Town of Arlington, MA Redevelopment Board

Agenda & Meeting Notice September 9, 2024

2. Public Hearing: Docket #3816, 5-7 Belknap Street

3. Public Hearing: Docket #3633, 1500 Massachusetts Avenue

Shadows – angle 1

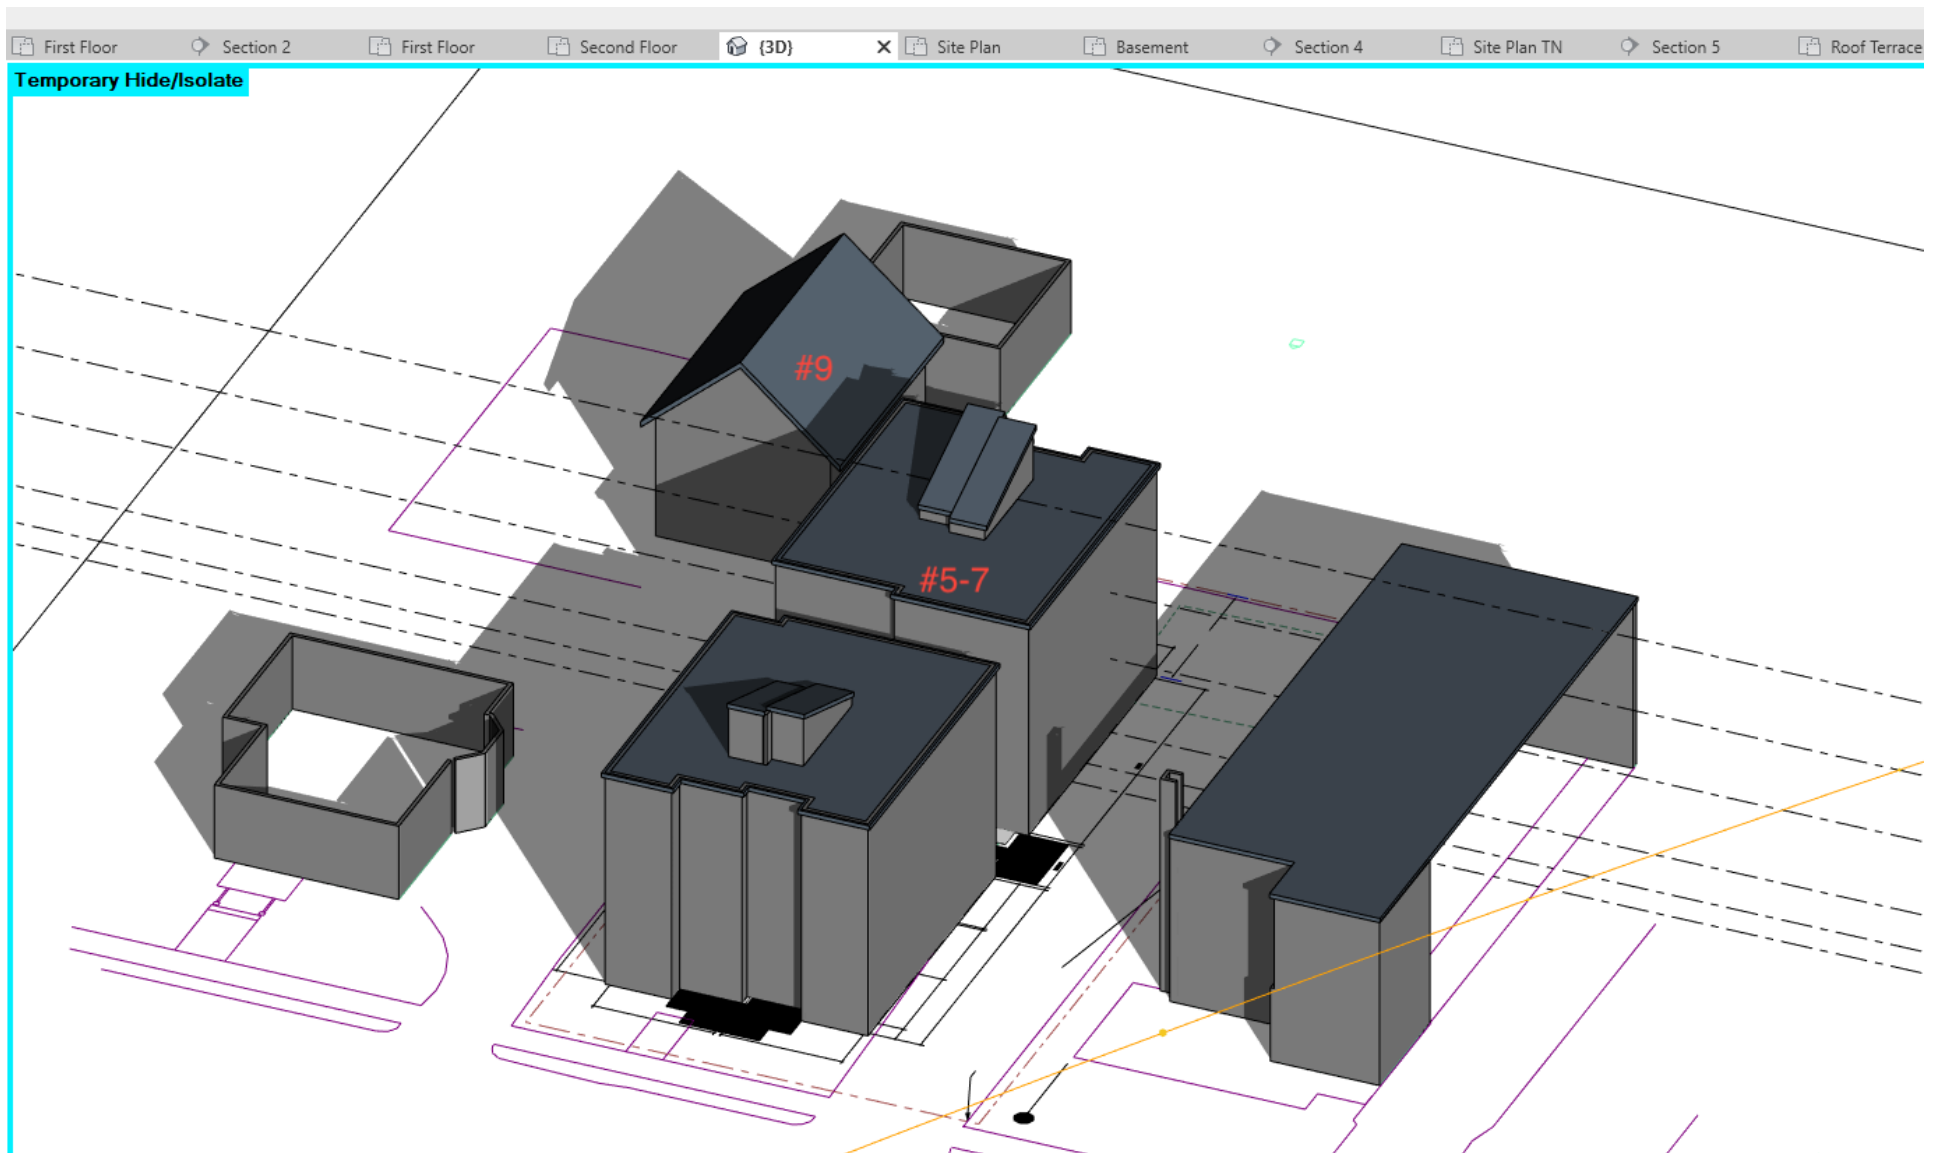
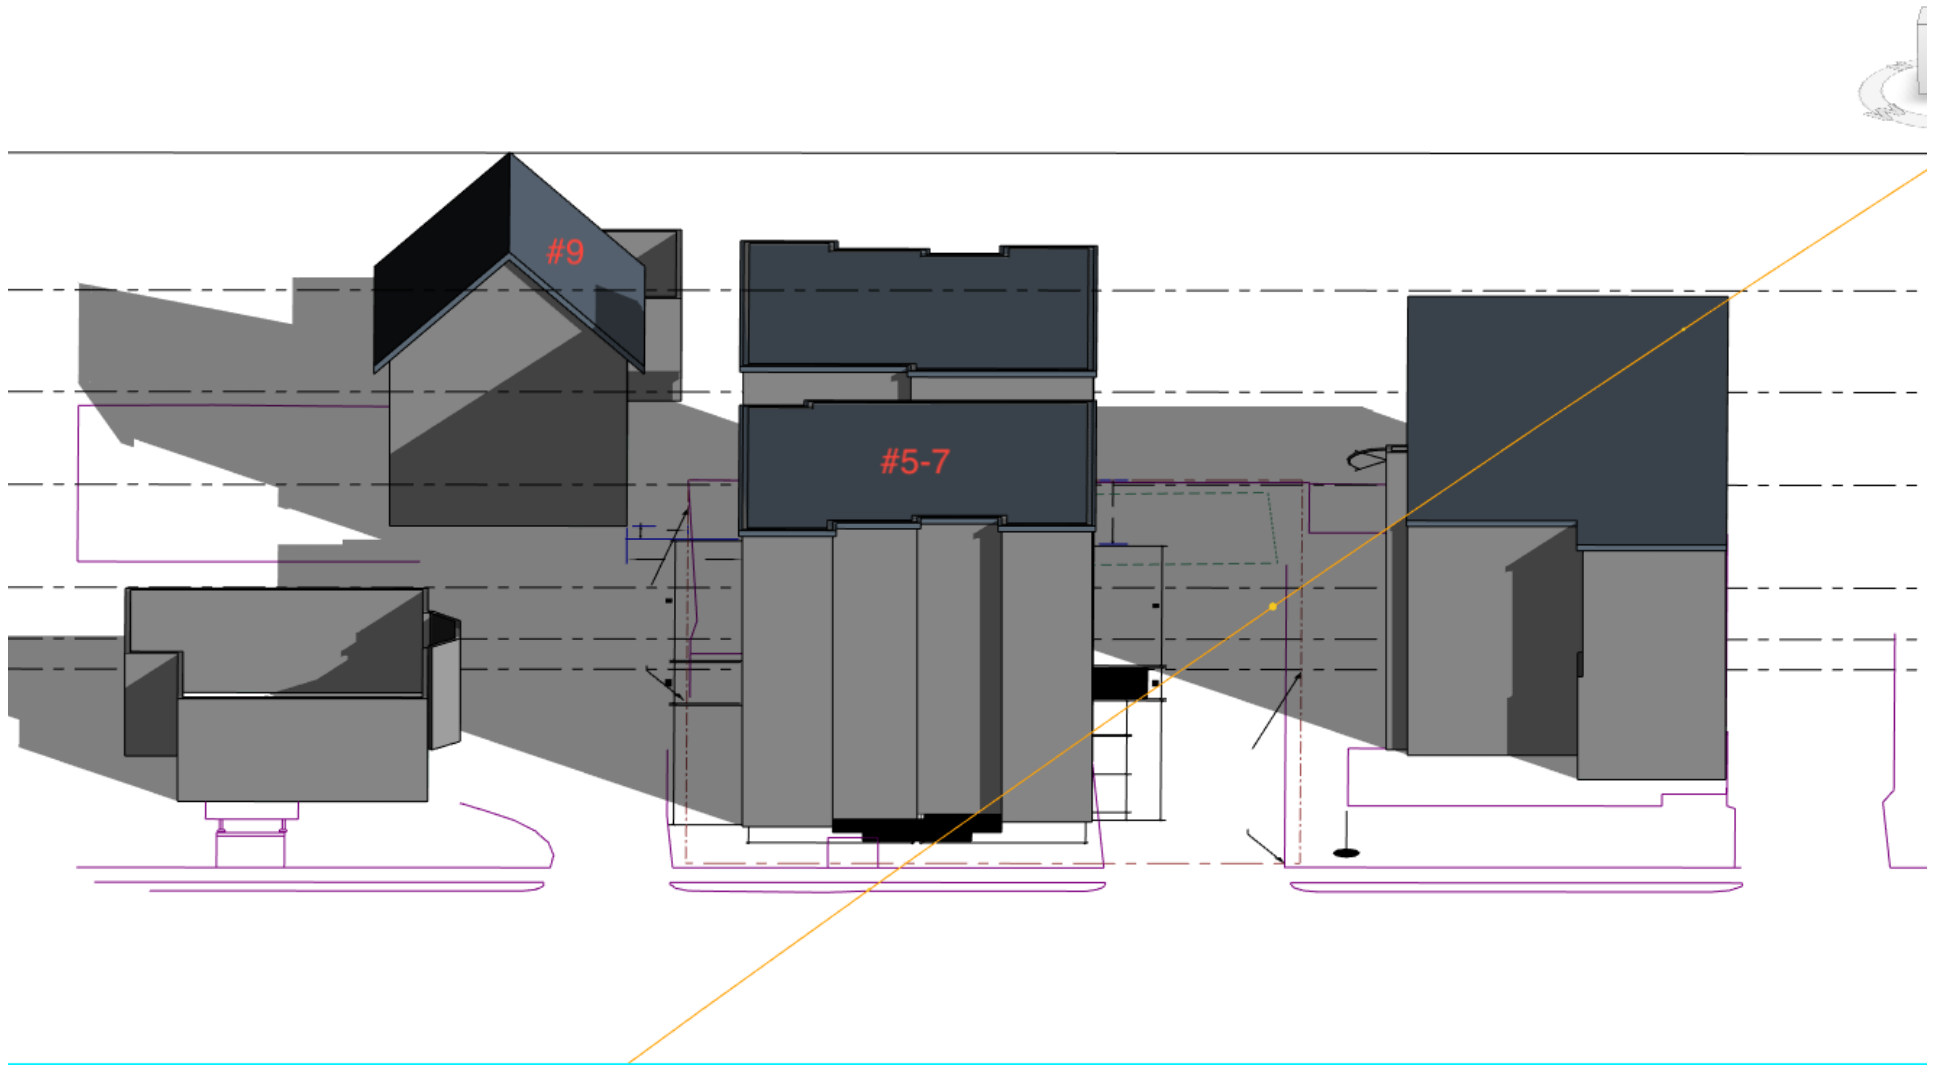
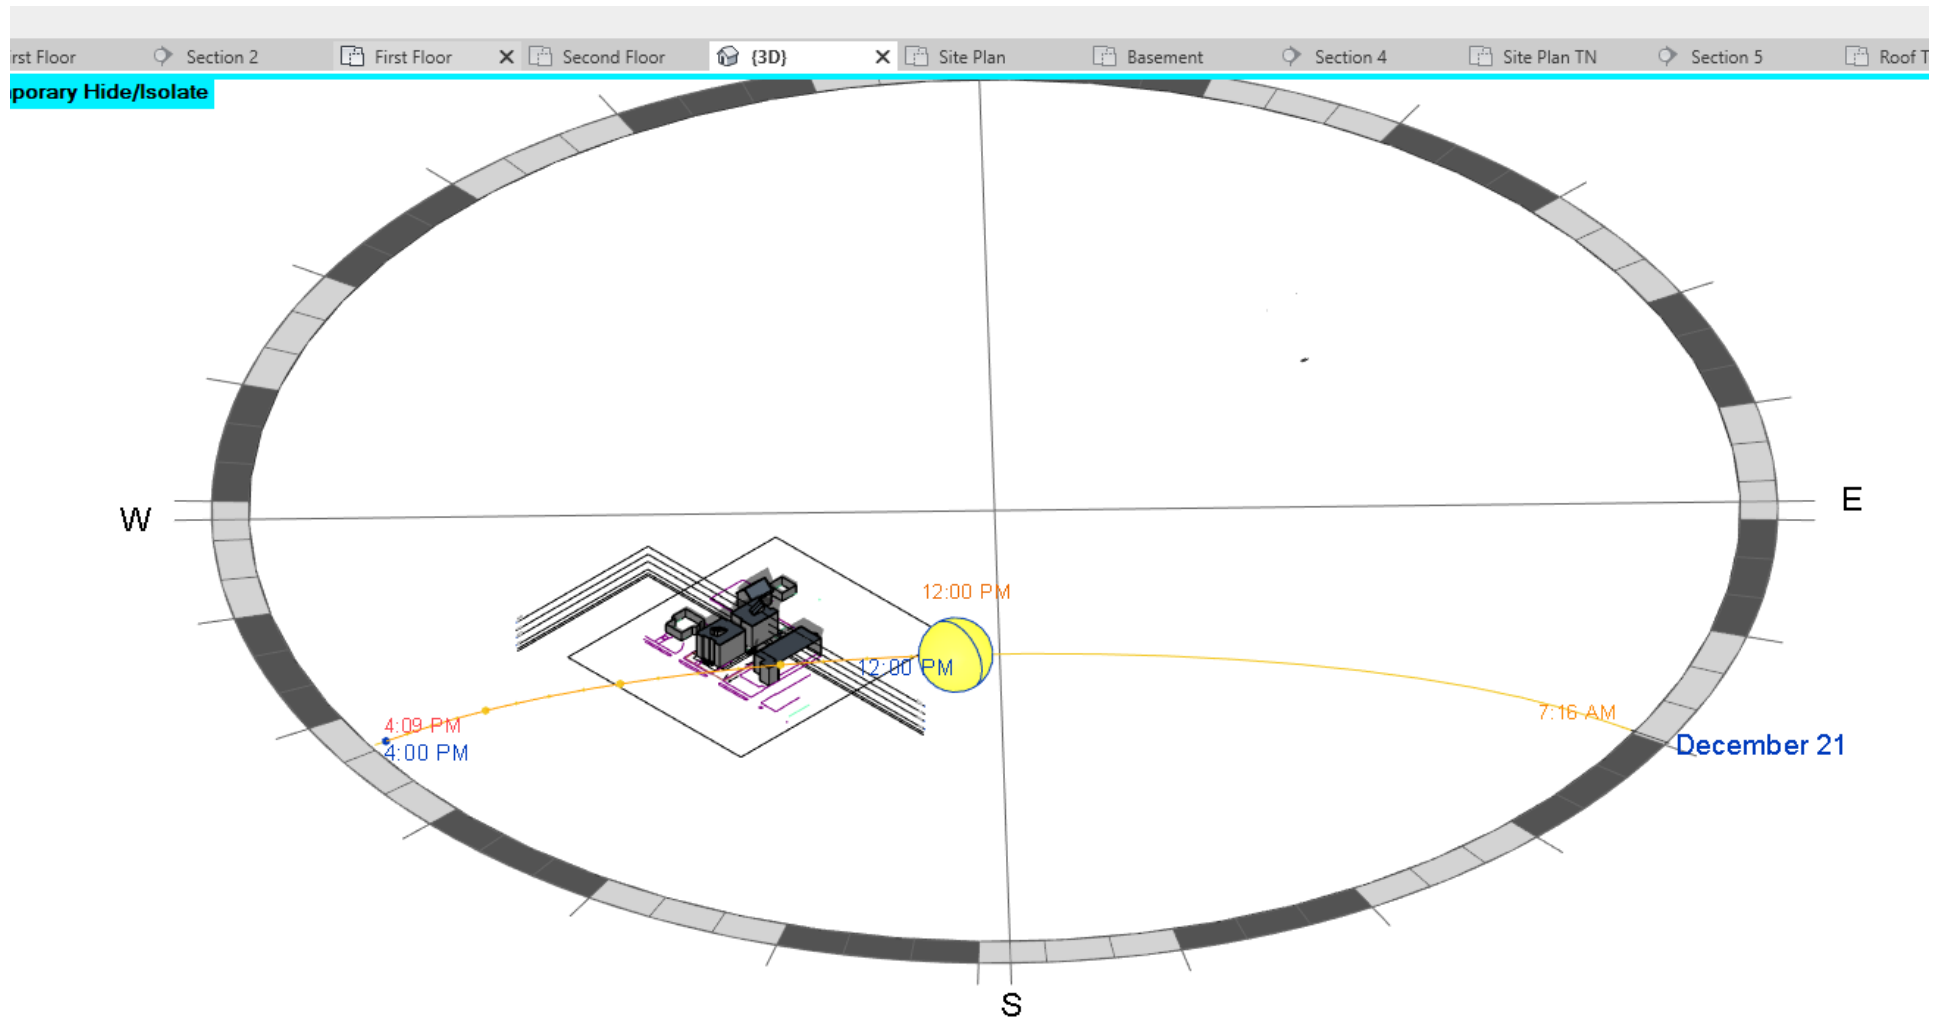
We understand you will be reviewing developer [Michael Collins' application for a special permit](#) to tear down the building next to us at 5-7 Belknap and build a much larger complex. His application for a special permit is cleverly written and gives the impression he is not building the albatross that he is proposing. After reviewing his plan and doing our own research, we feel that his proposal contains inaccuracies and misrepresentations about the impact of the plan.

For example: "The shadows that do fall onto the neighboring properties will be similar to the shadows currently cast from the existing building." And, "The existing site will be reused with small changes to the overall layout of hardscape and building footprint. No surrounding natural areas will be altered."

Our specific concerns are around the substantial shading this building will have over the front of our home, and the loss of privacy (for us and the tenants of the proposed building) as the new structure is extending 25' back and pushing out on the side to be 10' from our house. In one design Collins shared via email last week there's even a second-floor balcony proposed 10' from our children's bedroom window. Someone out there smoking or having loud conversation at bedtime would be very disruptive.

Attached are images from research that we commissioned: a shade study, and an overlay of the developer's plan onto the lot. We have shared these, along with our concerns with Collins.
